Application No. / Rhif Cais: **PA/20/00054/MJR**
Date / Dyddiad: **06/07/2020**

Pre Application Enquiry No : PA/20/00054/MJR

Proposal: DEMOLITION OF 188 RESIDENTIAL UNITS OF BETWEEN 2 – 4 STOREYS HIGH AND THE DEMOLITION OF THE 14 STOREY BLOCK OF FLATS TO ACCOMMODATE THE CONSTRUCTION OF 370 NEW RESIDENTIAL DWELLINGS. THE DWELLINGS WOULD PROVIDE A MIX OF 2 STOREY PROPERTIES AND BLOCKS OF FLATS OF UP TO 7 STOREYS HIGH AND AN OLDER PERSON'S SCHEME OF UP TO 15 STOREYS HIGH. PROPOSALS FOR THE SITE ALSO RELATE TO A SEPARATE PROJECT TO DEVELOP A NEW PEDESTRIAN/ CYCLE BRIDGE OVER THE RIVER TAFF LINKING THE AREAS OF GRANGETOWN AND BUTETOWN. THE MARL PUBLIC OPEN SPACE WOULD BE RE-DEVELOPED AS AN INTEGRAL PART OF THE PROPOSALS.

Location: CHANNEL VIEW, GRANGETOWN, CARDIFF

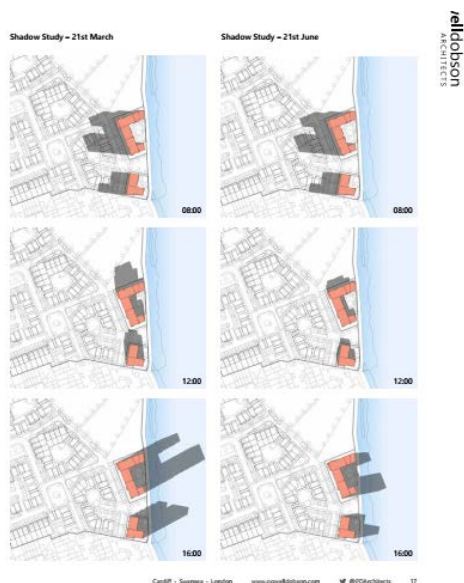
- Tall Buildings SPG becomes relevant.
- There are several possible weaknesses with these blocks.
- A revised shadowing study should include the whole of the site, not just the tall buildings. The buildings to the west side of the street are likely to be in shadow from the tall building for part of the day (as is shown), and then within their own

shadow later in the day, which has not been made clear. This impacts on the amenity and quality of life for those residents concerned.

3D Image showing relationship of towers to the river edge

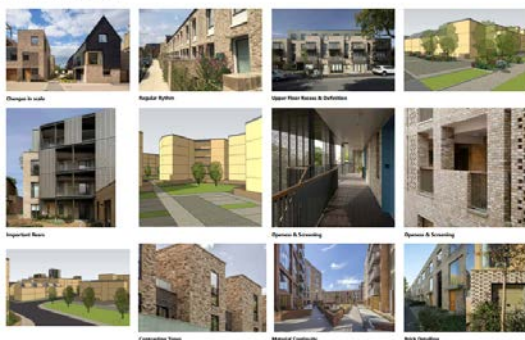
The architectural approach is positive. The architects could carry this forward into the detailed design, ensuring balconies for private amenity space.

- The layout and orientation of the units generally ensures sufficient daylight. It is suggested that that lower units with less sunlight in the winter could have bigger windows.
